Our ref: NI2702

Date: 28th February 2025

LA08/2024/0259/F - Installation and operation of a 29.9MW solar farm on lands south of Magheralin and southeast of Dollingstown

Figure 1: HED Historic Monuments Consultation Response dated 05.08.24

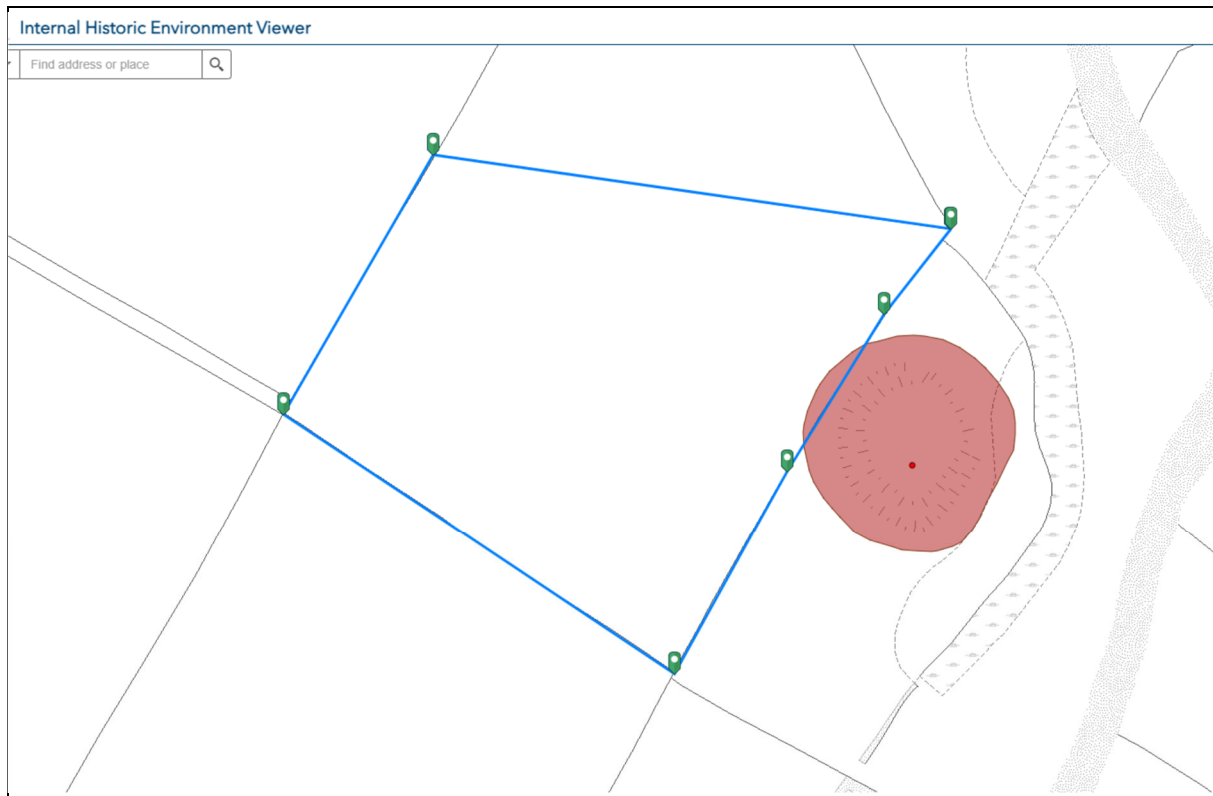
We welcome the proposed exclusion zone but consider that this should be expanded from the proposed northern extent to the existing field boundaries at west, east and south- see Figure 1 below. This area should be entirely excluded from all development works, including the fence line noted above. This is to ensure the physical protection of the scheduled monument and associated below ground archaeological remains, but also to ensure the protection of the integrity of the immediate setting of the scheduled monument.

Figure 4 Site Layout 05215-RES-LAY-DR-PT-005 Rev 8.1, submitted previously for Council consideration on 30th August 2024, removes all proposed project components from the area outlined in blue on Figure 1 included above.

In the intervening period, a further layout amendment has occurred to address Council comments regarding land-parcel 4, which is at the south of the Proposed Development site. The additional amendment is reflected on Figure 4 Site Layout 05215-RES-LAY-DR-PT-005 Rev 12, which accompanies this submission, replacing the previous iteration.

For the avoidance of doubt, the area shown on Figure 1 above, continues to remain free from development proposals.

Appendix 2 - Annex 1
Photomontage – Front of Springhill House towards Parcel 1 lands

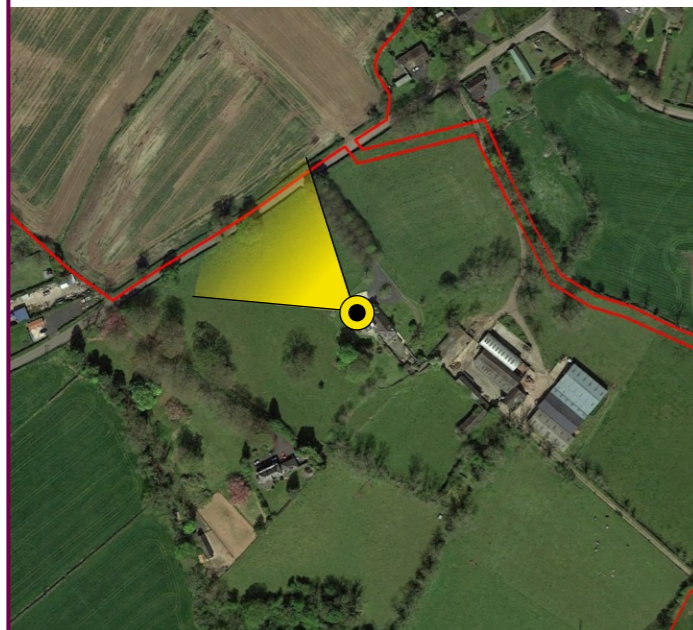
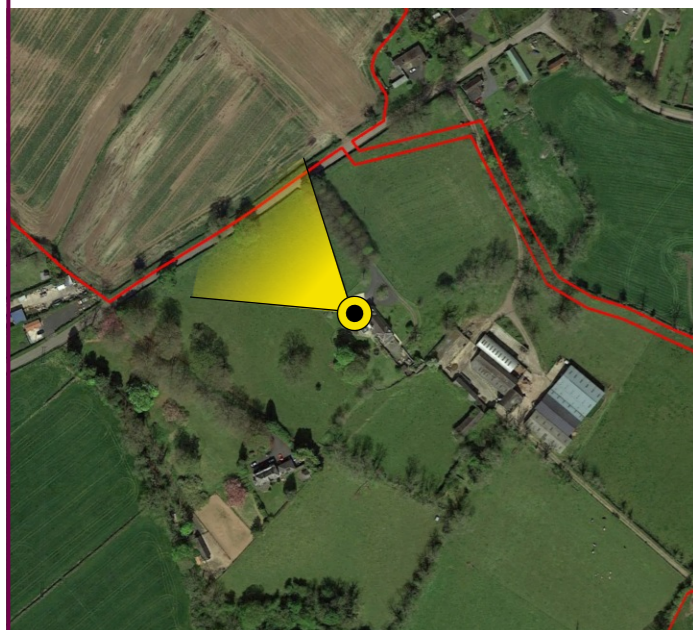
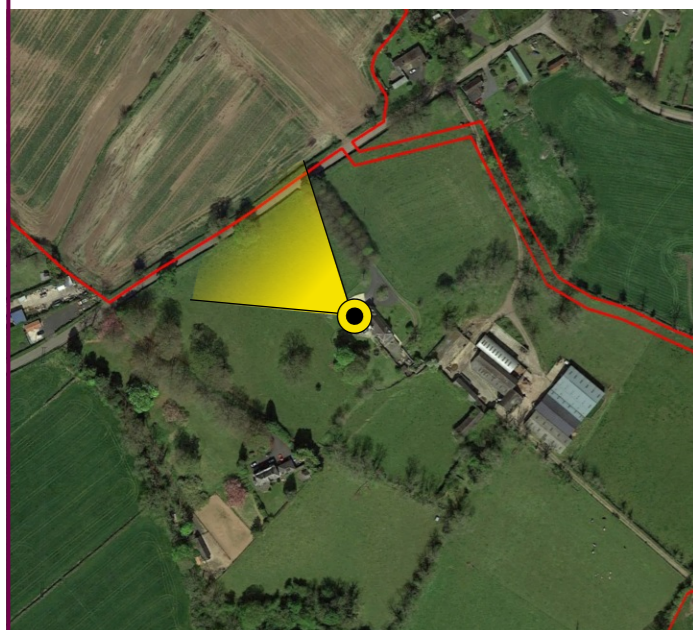
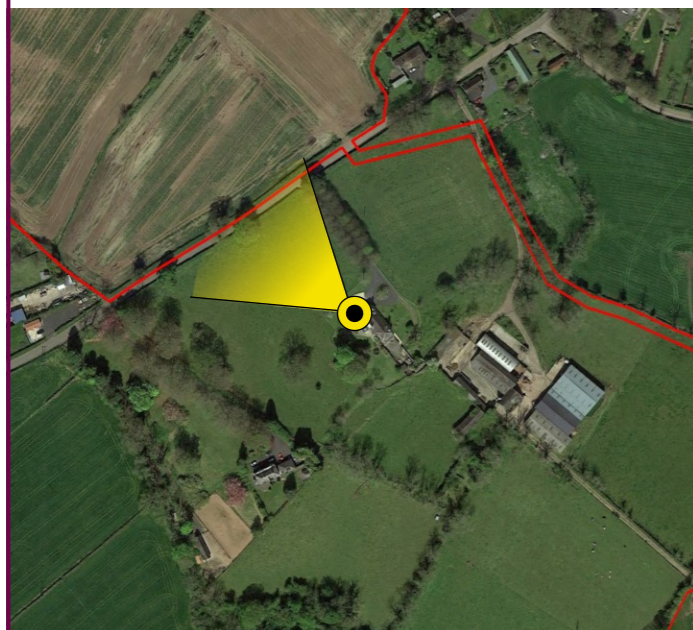
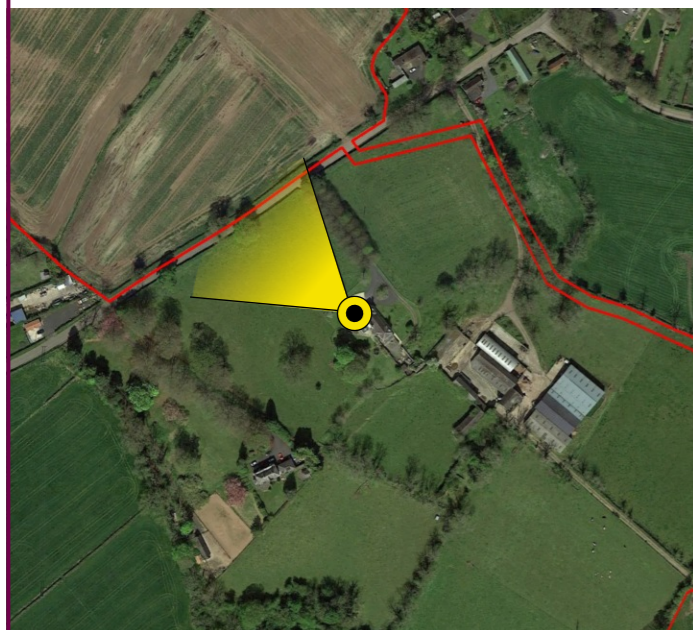
HED Historic Buildings requests the following information to assess the impact of views of the proposed development on the nearby listed asset against Policy:

- **Site sections through field adjacent to Springhill house to include the listed building, PV panels and proposed and extant hedgerow planting.**
- **Photomontage illustrating view of PV farm from front of Springhill House during winter months.**

- Drawing 2702.5.10 Rev H which accompanies this submission provides two Sections through the Parcel 1 lands of the Proposed Development as well as the garden of Springhill House located to the southeast of Parcel 1.
- The accompanying Photomontage provided as Annex 1 to Appendix 2 illustrating the view from the front of Springhill House towards Parcel 1 lands. As requested, a wintertime montage is provided. A summertime montage is provided also for completeness. The montage has been given the reference number "Viewpoint 12."

The Archaeological and Cultural Heritage Assessment submitted as part of the planning application pack sets out that from here views of the Proposed Development are screened by existing mature hedges along Springhill Road and a mature tree-lined avenue located north / north-west of the house. The Cultural Heritage Assessment concludes that, *"Given the current level of screening provided by the existing hedges and trees and the additional screening that further hedge planting would provide, the potential indirect visual impact may be considered to be imperceptible."*

This conclusion is reinforced by the Section and Montage provided, as referred to in the bullet points above.

Updated Photomontage 10 – now referenced VP10 Rev A

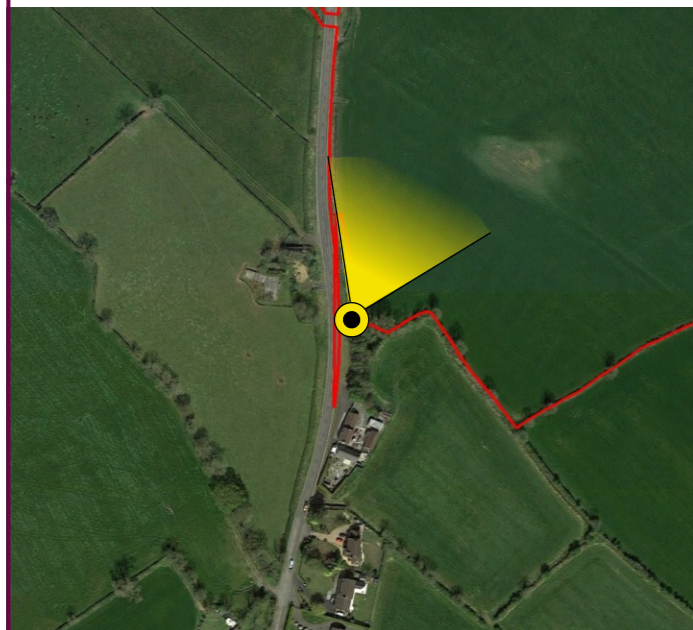
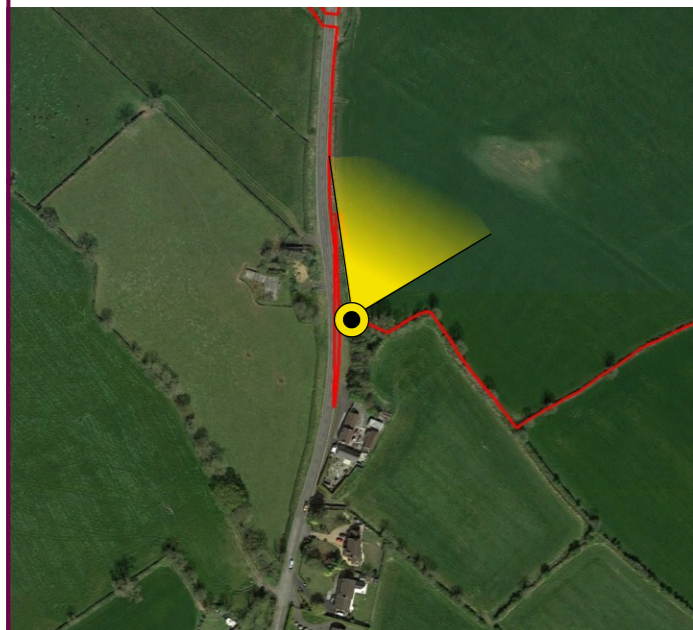
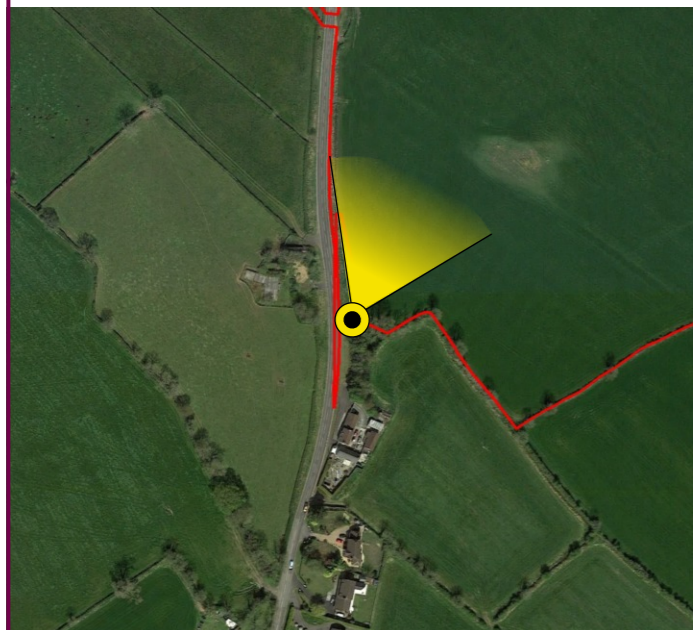
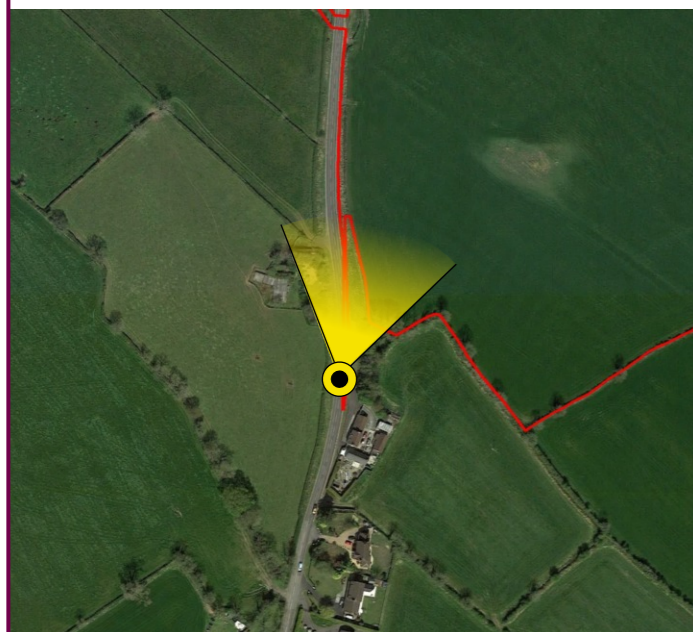
Comment/Clarification Raised

For completeness, Photomontage 10 which formed part of the Landscape and Visual Impact Assessment (LVIA) submitted as part of the planning application pack, is taken along Drumlin Road, and has been updated to reflect revised layout and landscaping proposals – now referenced as VP10 – Rev A. A further long-distance view is taken from further south along Drumlin Road and is referenced as VP10A. Both montages are provided as Annex 2 to Appendix 4. This reaffirms that to viewers along the roadside, potential views of the site will be screened.
